**PREVOST**

## **WARRANTY BULLETIN**

Wb08-20

<b>DATE : NOVEMBER 2008</b>	<b>SECTION : 06 - Electrical</b>
<b>EXPIRATION: NOVEMBER 2010</b>	
<b>SUBJECT: RELOCATION OF BERU FRONT ANTENNA SUPPORT AND CHANGE OF HARNESS</b>

FIGURE 1

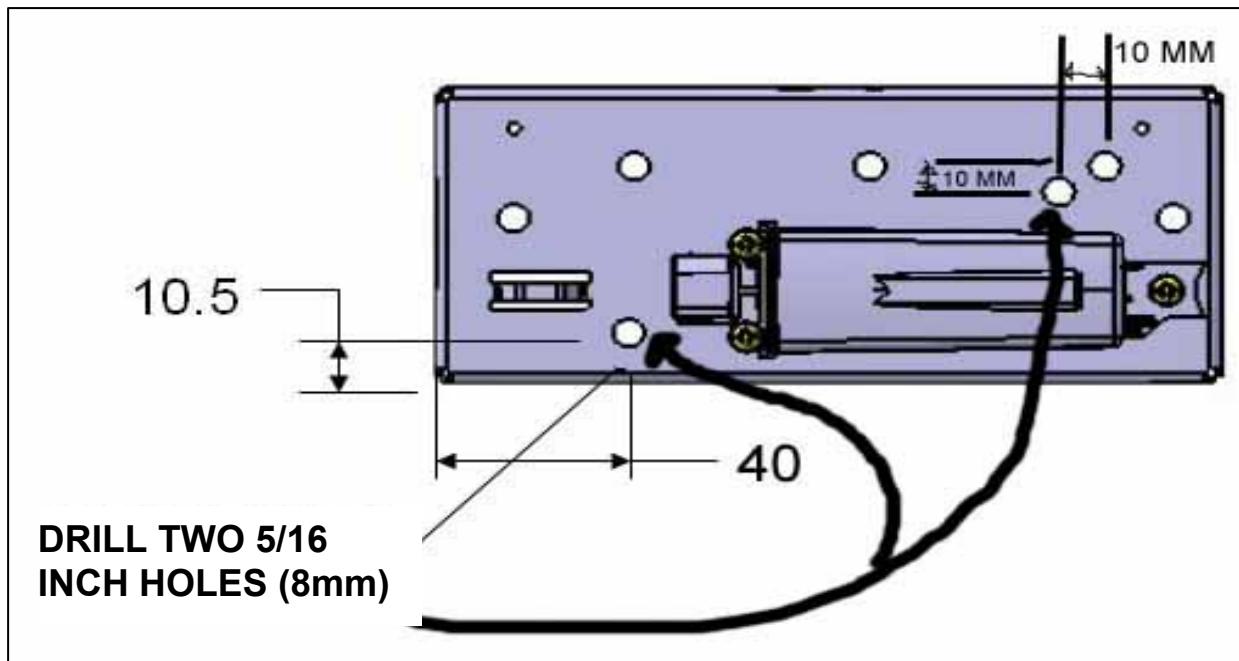
1. Remove Beru antenna support located in the front wheelhousing (Refer to figures 1 and 2).

2. Drill two 5/16 inch (8mm) holes into the support. Refer to figure 1 for holes location.
3. Position support onto structural diagonal post at the location indicated in figure 2 and drill two 3/16 inch holes.
4. Also drill a 3/16 inch draining hole in the lower part of the diagonal post (Refer to figure 2).

FIGURE 3

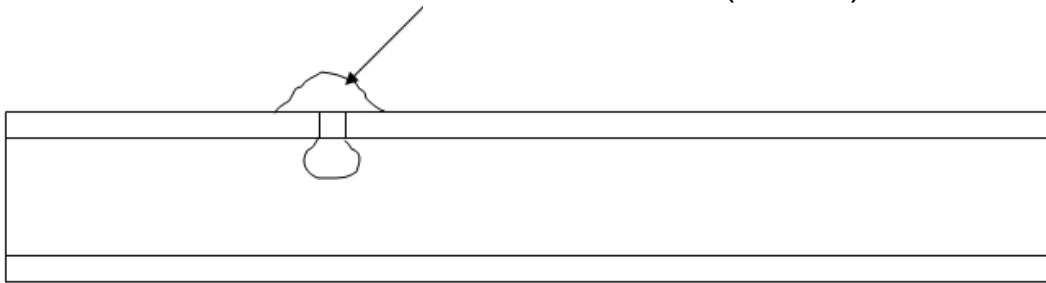
5. Clean surface near the two support fixing holes using anti-silicone.
6. Apply Sika 221 onto holes surface for watertightness.

BEFORE FIXING SUPPORT FILL  
DIAGONAL POST HOLES WITH SIKA 221  
AND LEAVE AN EXCESS ON TOP OF THE  
HOLES  $\frac{3}{4}$  INCH (19 mm)

FIGURE 4

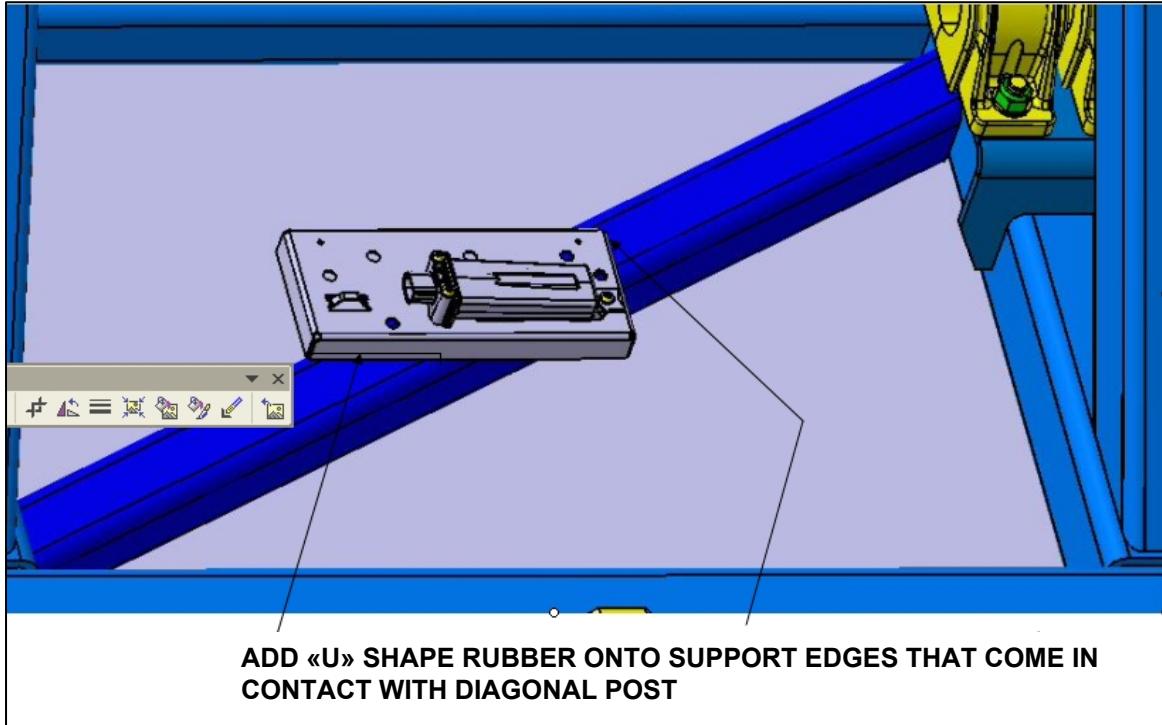
7. Add "U" shape rubber onto support edges that come in contact with diagonal post.

FIGURE 5

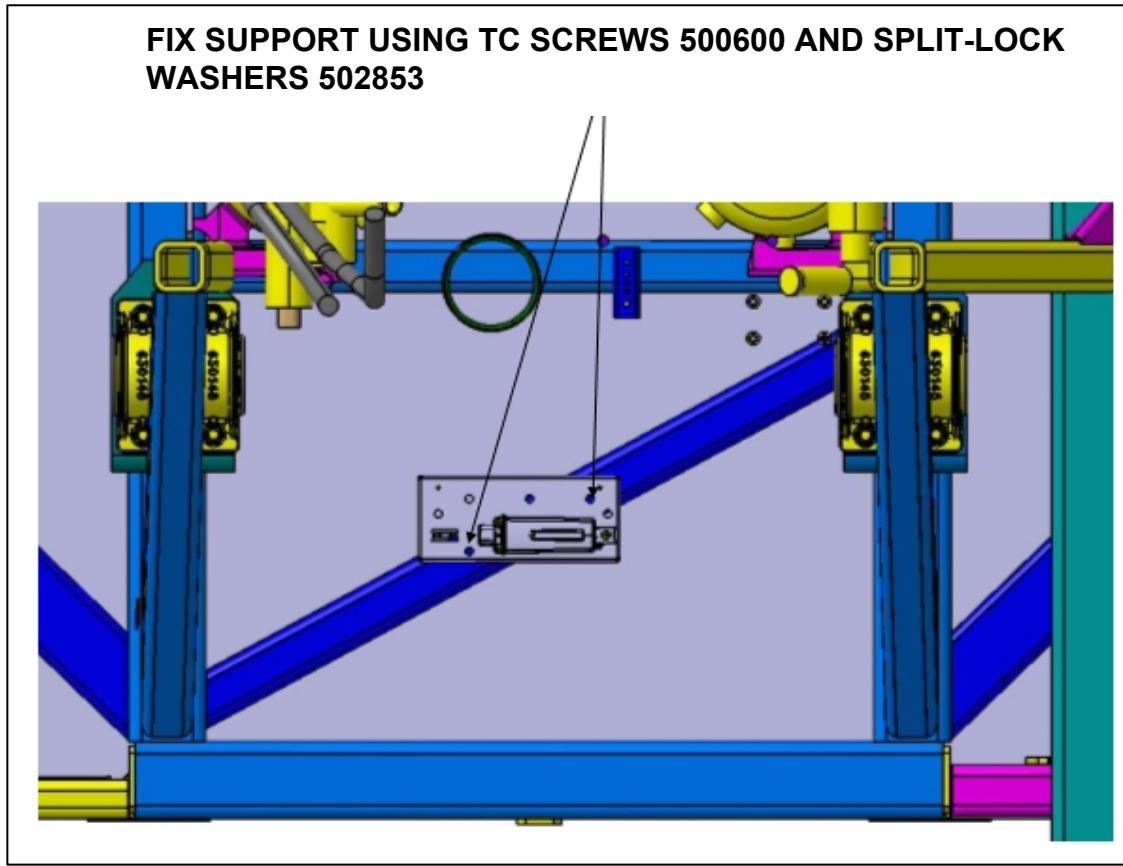
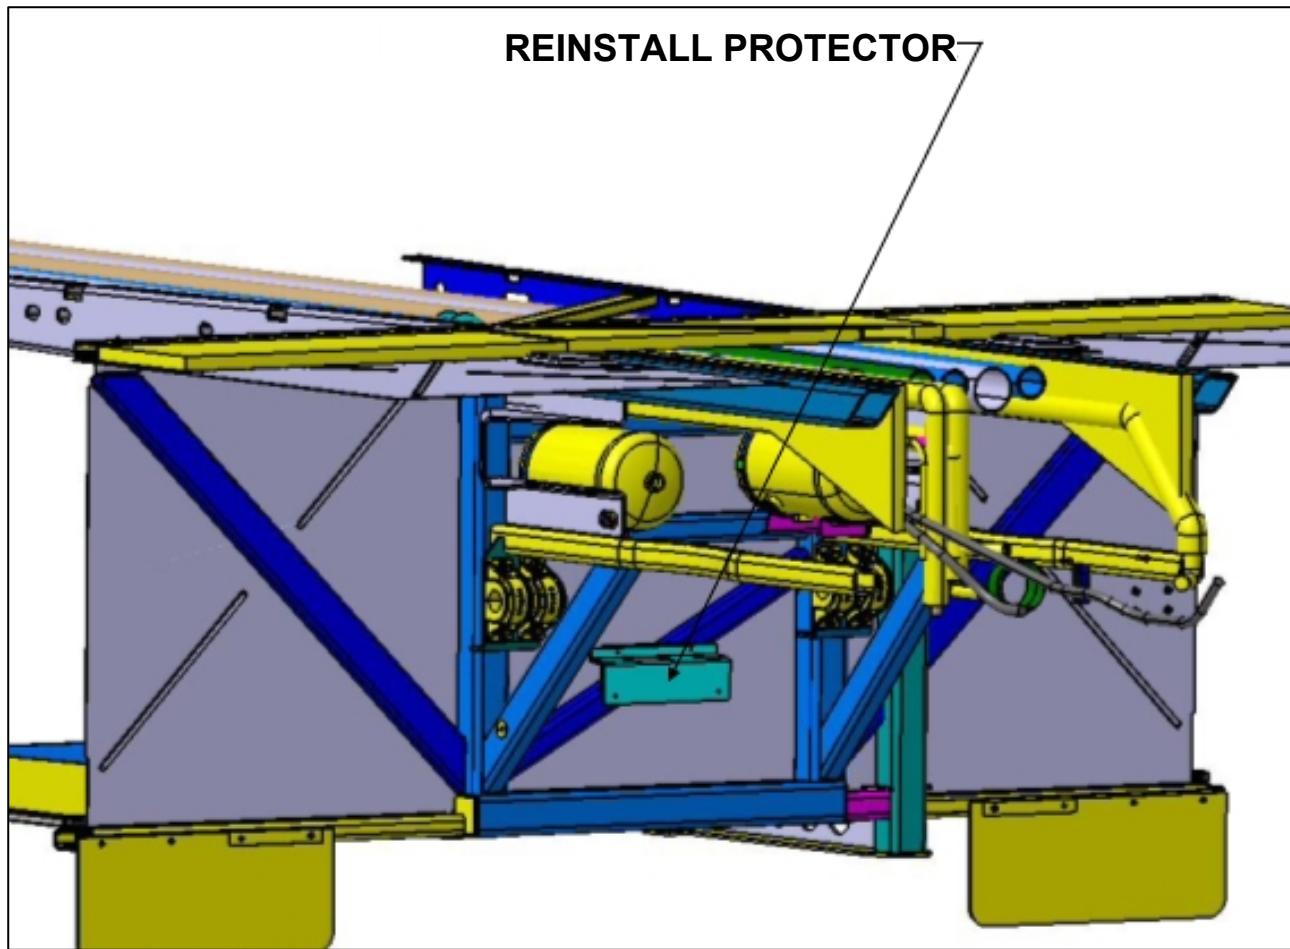
8. Fix support using two thread cutting screws and split-lock washers.
9. Connect new cable harness 067585.
10. Reinstall protector.
